NEW ELEMENTARY AND MIDDLE SCHOOL

CONTENTS - VOLUME TWO

phase	Bid Package No. 2
date	January 3, 2008
ADD	October 17, 2007
ADD	October 26, 2007
ADD	November 2, 2007
ADD	November 5, 2007

project # 06022

Lighting Plan
Sector "A"

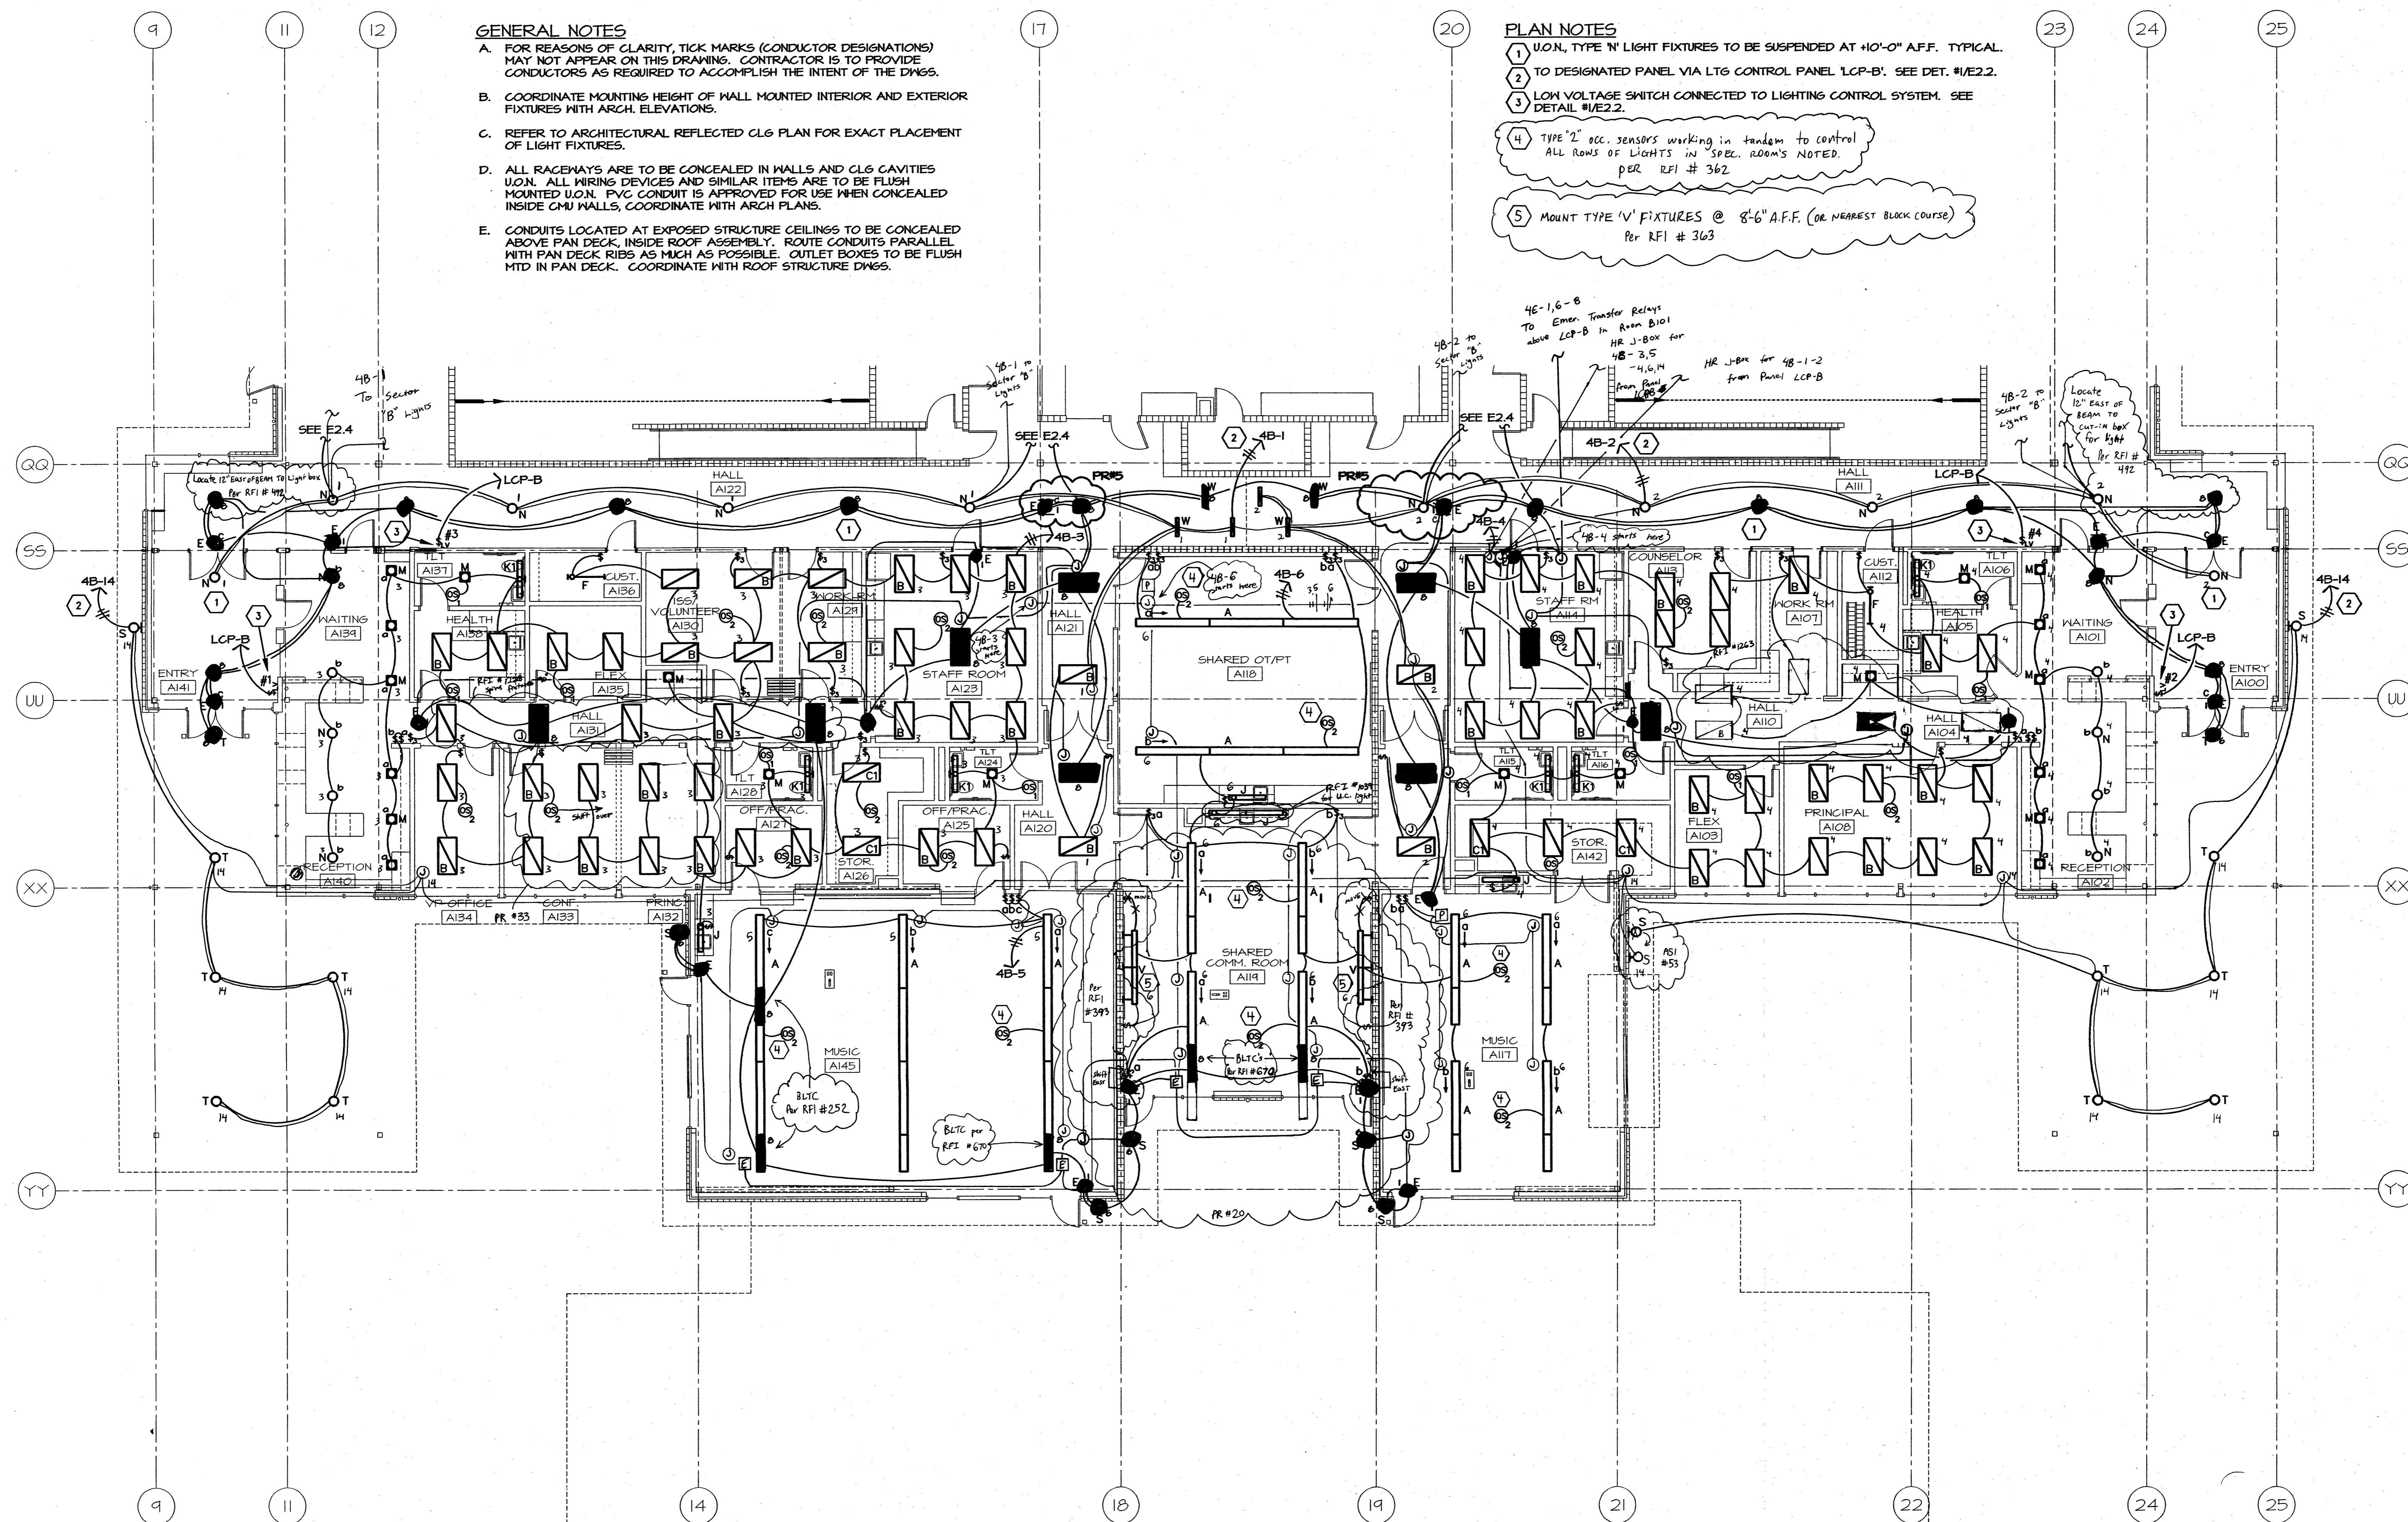
- U.O.N. TYPE 'N' LIGHT FIXTURES TO BE SUSPENDED AT 10'-0" A.F.F. TYPICAL.
- TO DESIGNATED PANEL VIA LTG CONTROL PANEL 'LCP-B'. SEE DET. #1/E2.2.
- LOW VOLTAGE SWITCH CONNECTED TO LIGHTING CONTROL SYSTEM. SEE DETAIL #1/E2.2.
- TYPE 'Z' OCC. SENSORS WORKING IN TANDUM TO CONTROL ALL ROWS OF LIGHTS IN SPEC. ROOMS NOTED. PER RFI # 362.
- MOUNT TYPE 'V' FIXTURES @ 8'-6" A.F.F. (OR NEAREST BLACK COURSE) PER RFI # 363.

project # | 06022
Lighting Plan
Sector "B"

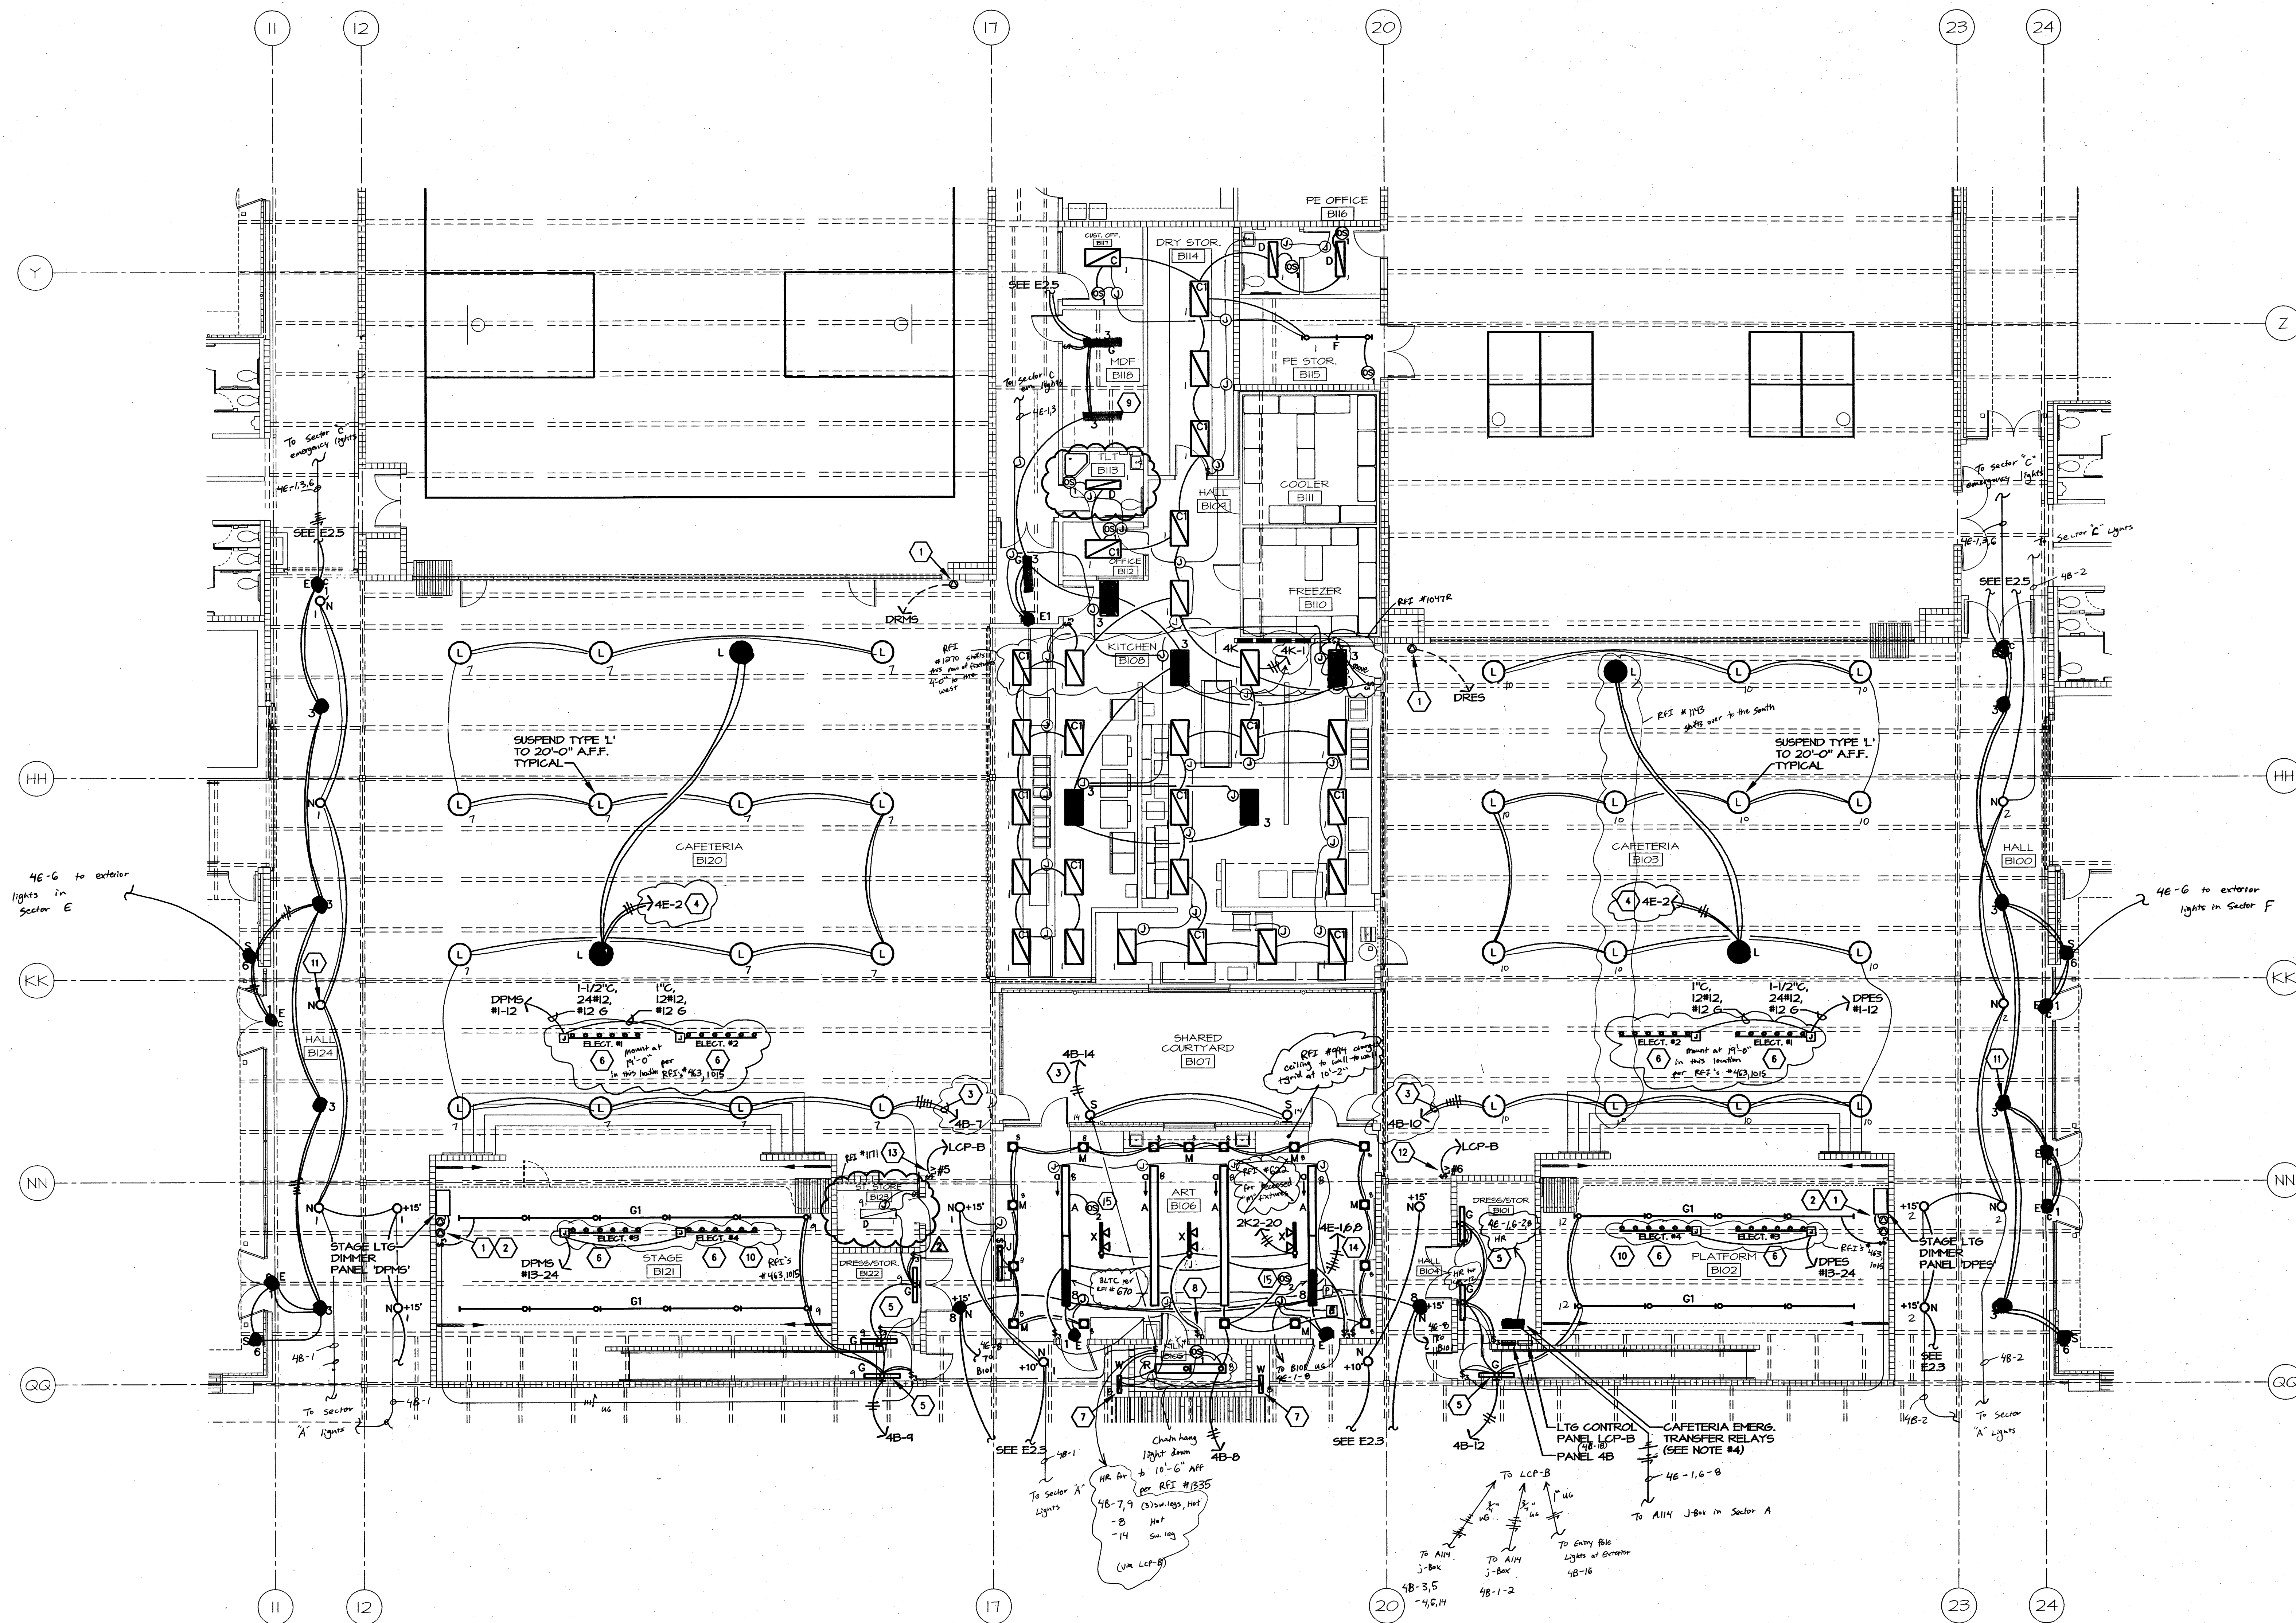
- 5 TYPE '6' FIXTURE(S) IN THIS ROOM TO BE WALL MOUNTED AT +10'-0".
- 6 THEATRICAL LIGHTING ELECTRIC. SEE SPECIFICATIONS. PROVIDE MTS BRACKETS FOR EACH ELECTRIC. MOUNTING BRACKETS SUPPORT BOTH THE ELECTRIC AND THE FIXTURE PIPE - ETC TYPE '21' OR APPROVED. FIXTURE PIPE BY ARCHITECT. RFI # 463.

- 15 TYPE '2' occ. sensors working in tandem to control all Rows in Hotel Rooms. Per RFI # 362.

1 LIGHTING PLAN - SECTOR "C"
E2.5 SCALE: 1/8" = 1'-0"

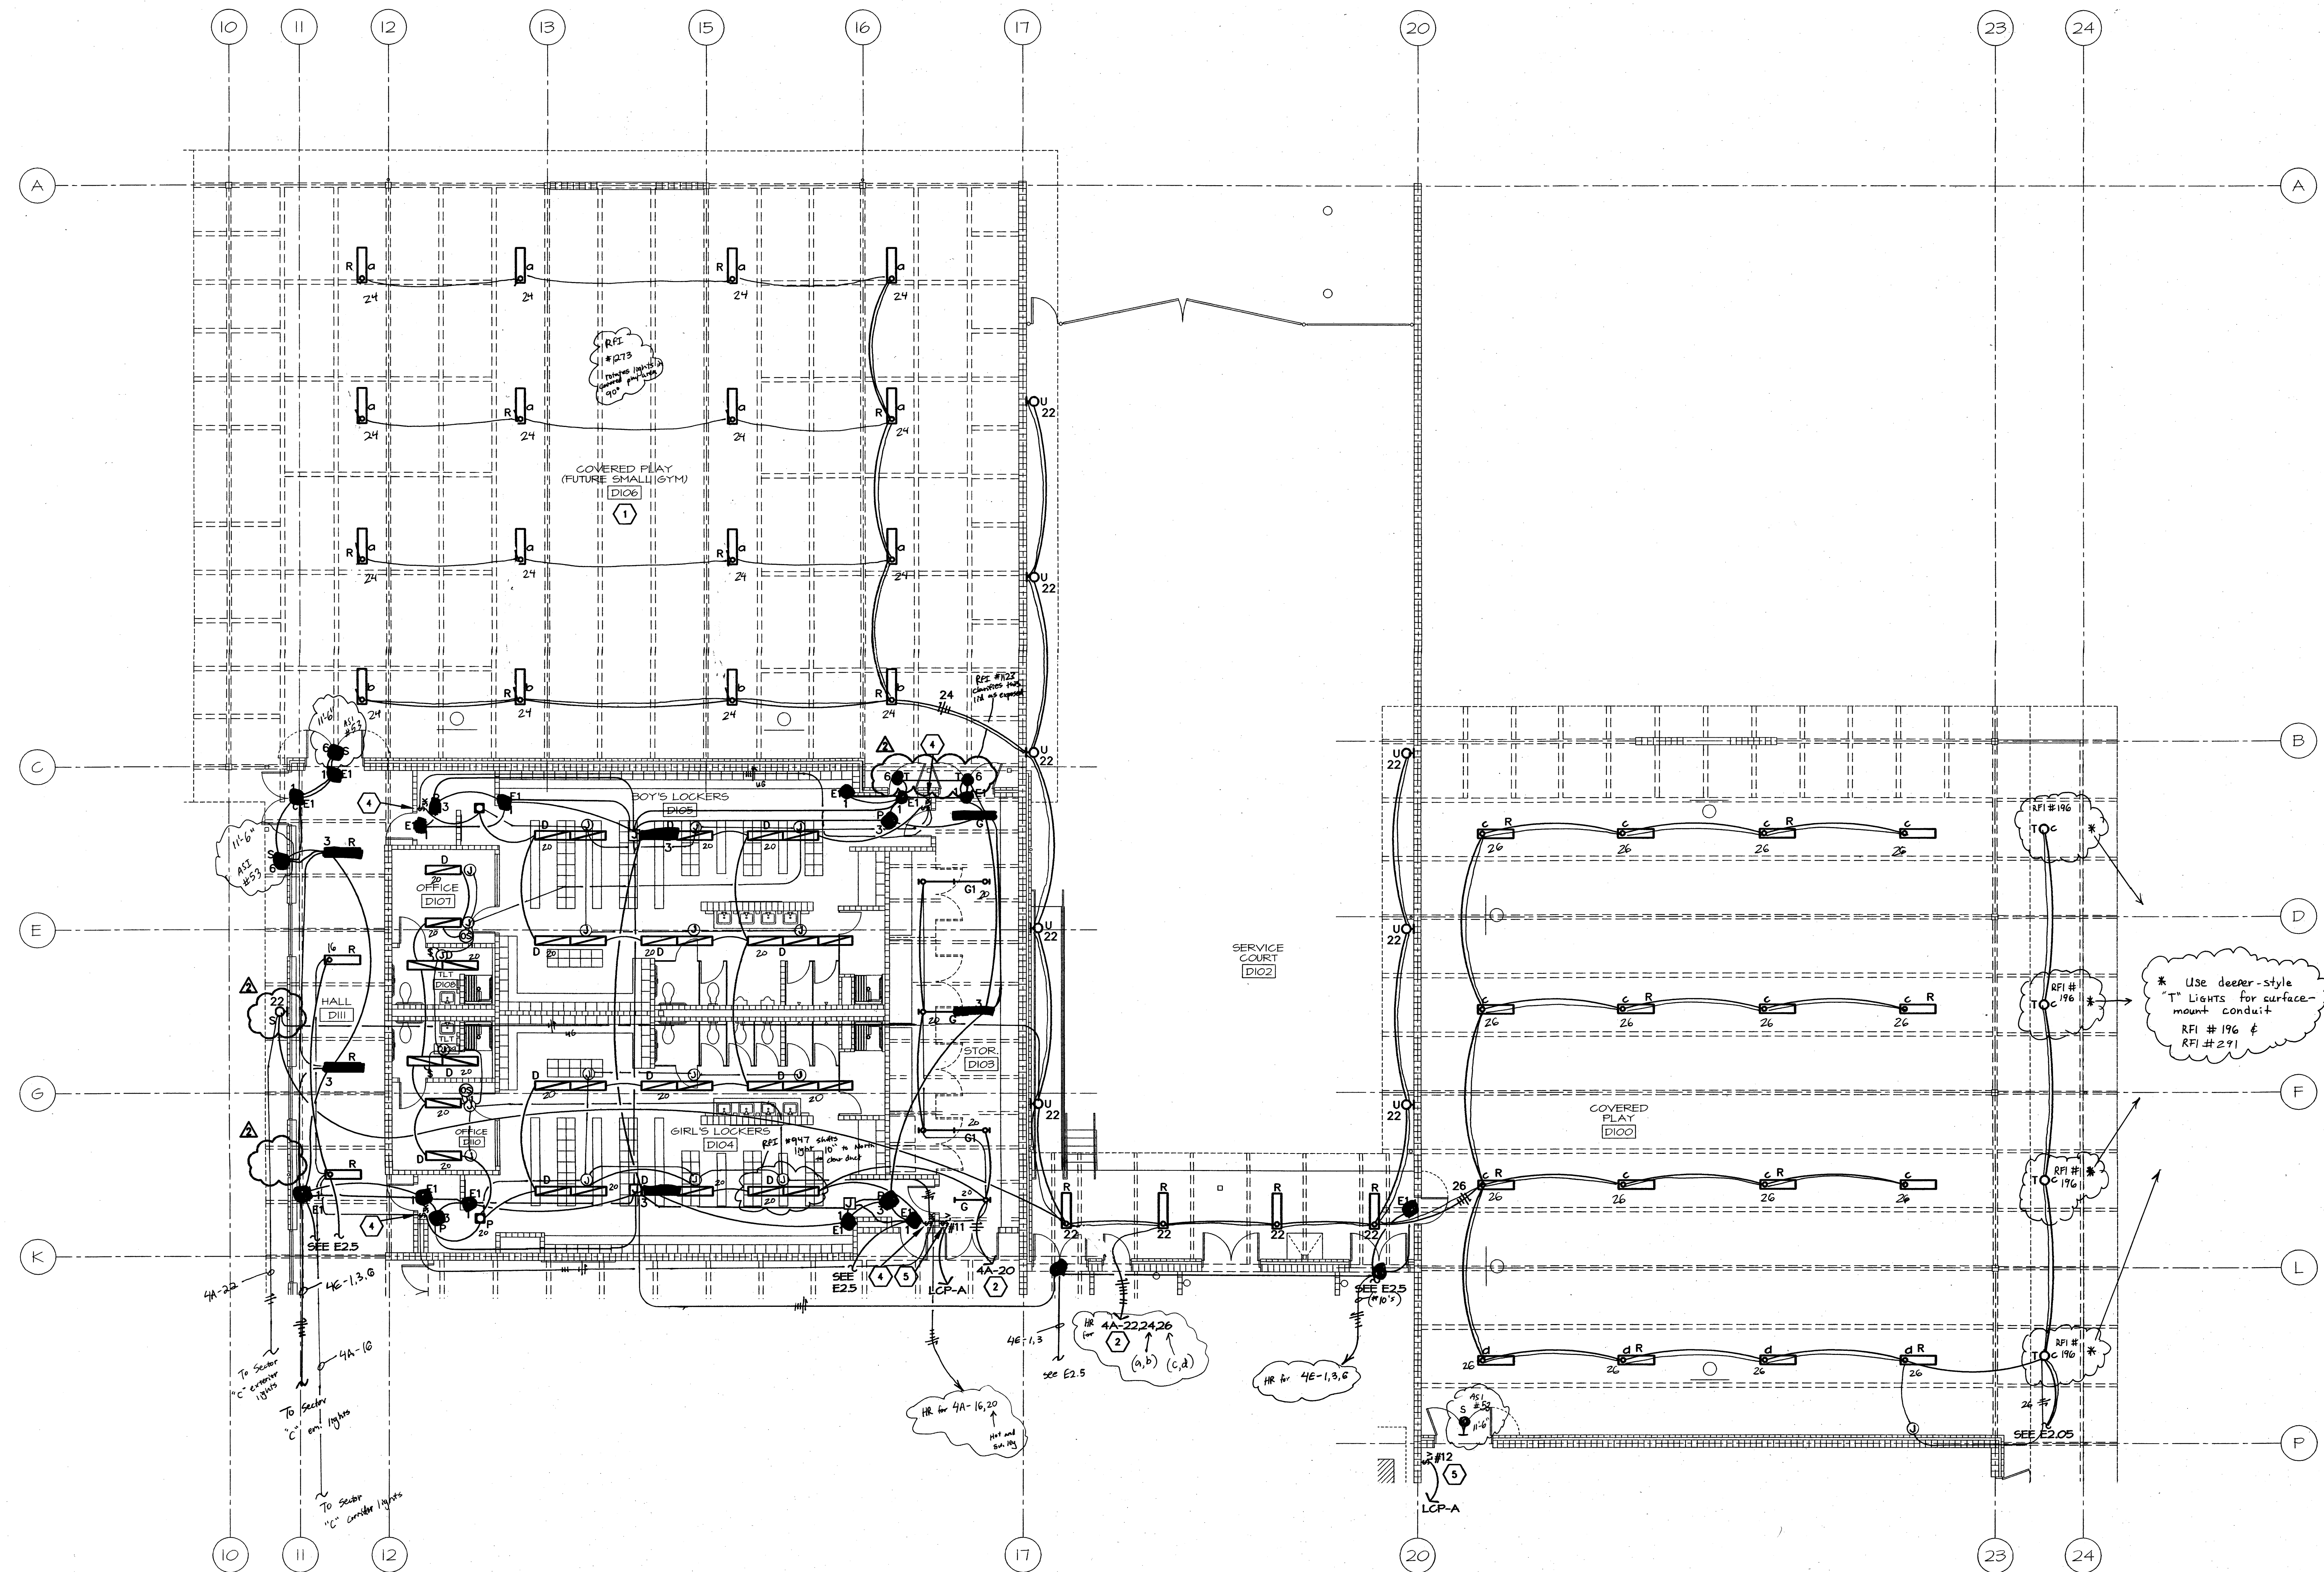
Use standard locking switches as noted in e-mail response to RFI #1164 from Turner on 3-15-07
